PROPOSED ALTERATIONS & ADDITIONS
84 AMOHIA STREET SH1 PARAPARAUMU
DECEMBER 2000
JOB NO. 1309

BUILDING CONSENT 010067 – 84 AMOHIA STREET, PARAPARAUMU

BF010067 – COMMERCIAL BEAUTY THERAPY CLINIC

Floor plan 1:50

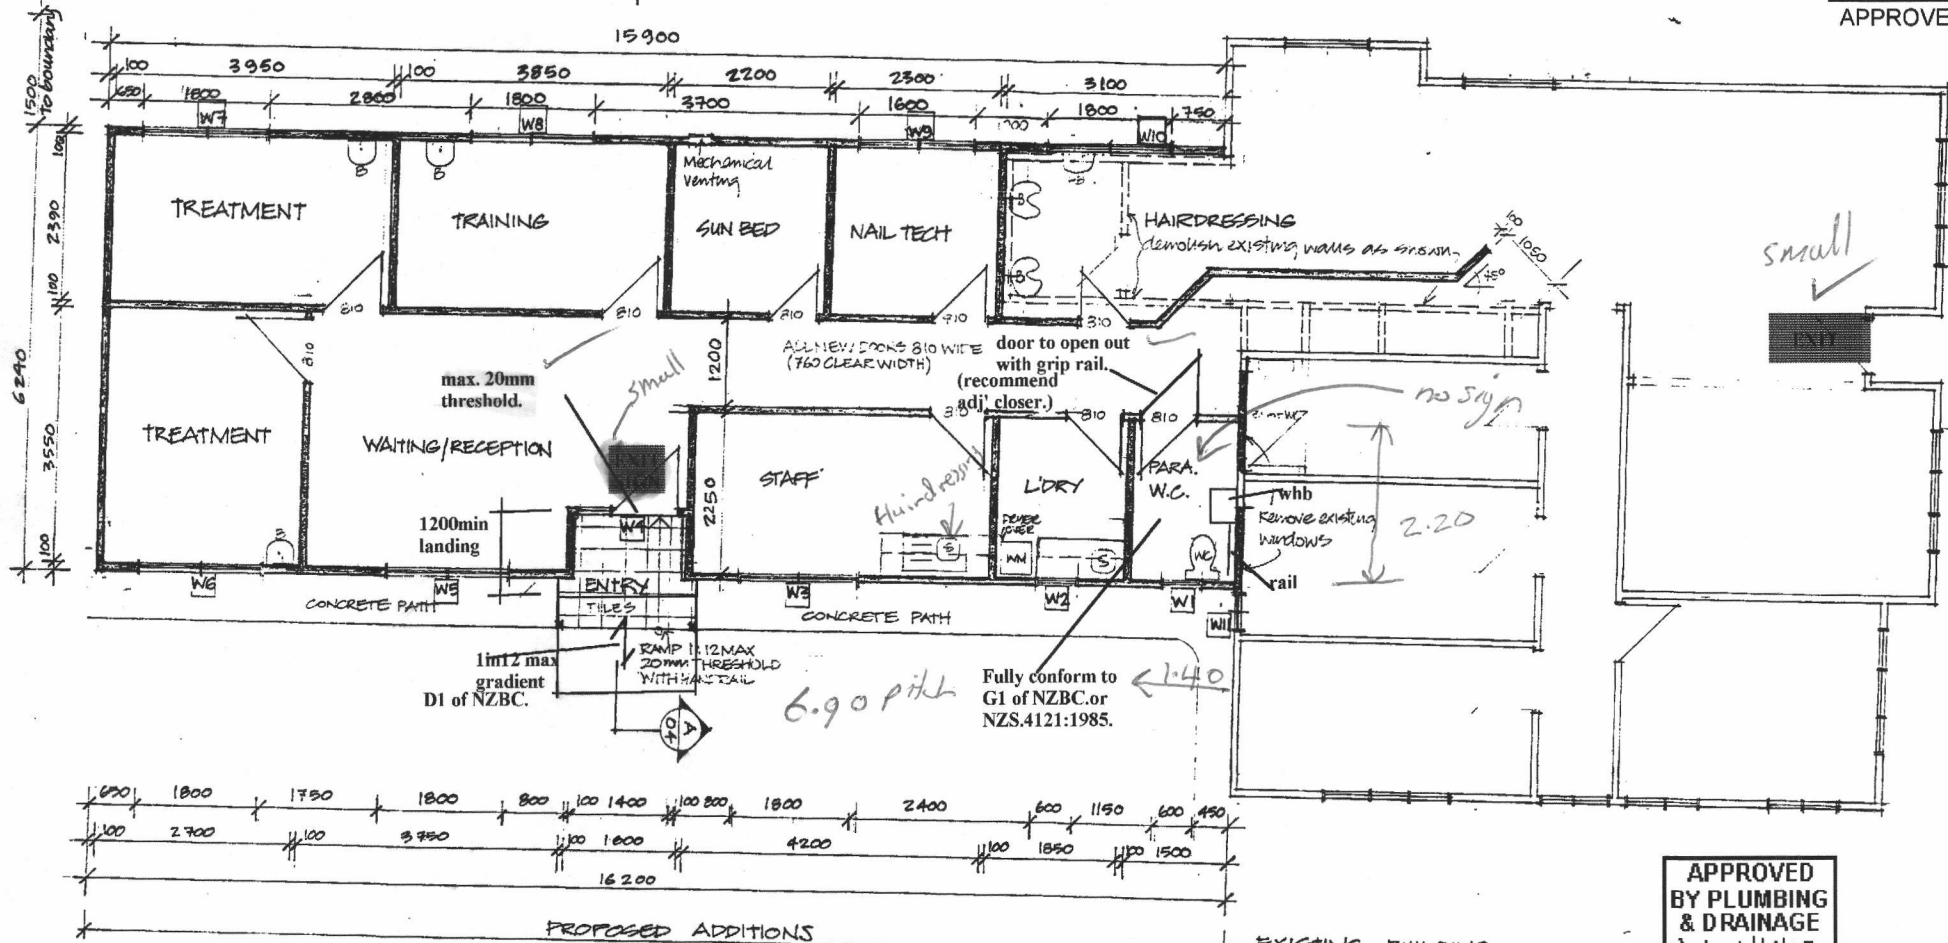
1. Install a tempering valve on the hot water supply to the hand basins. Max 55deg C

2. A testable type backflow prevention device is required on the water supply to the hair wash basins.

site plan 1:100

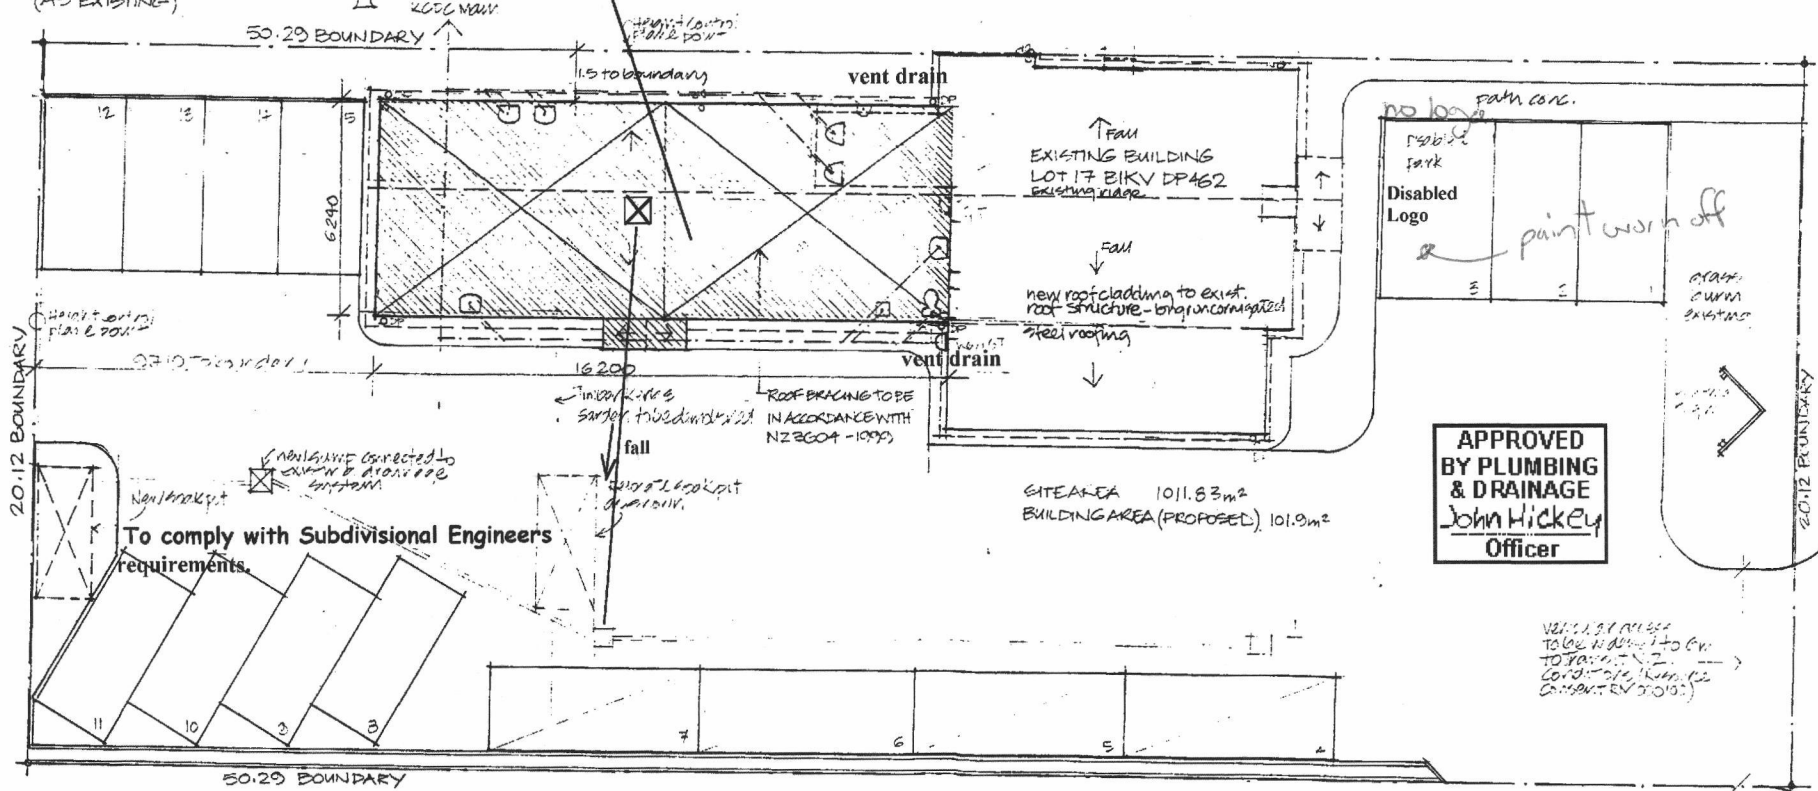
Ground level below subfloor to be lowered to meet subfloor crawlspace/ventilation/floor material clearances of NZS.3604:1999.

Fix polythene to ground well secured and taped around all penetrating piles.

Connect gravity feed sump from subfloor space into existing stormwater system. (A pump and float switch is required if a gravity fed drain cannot be achieved.)
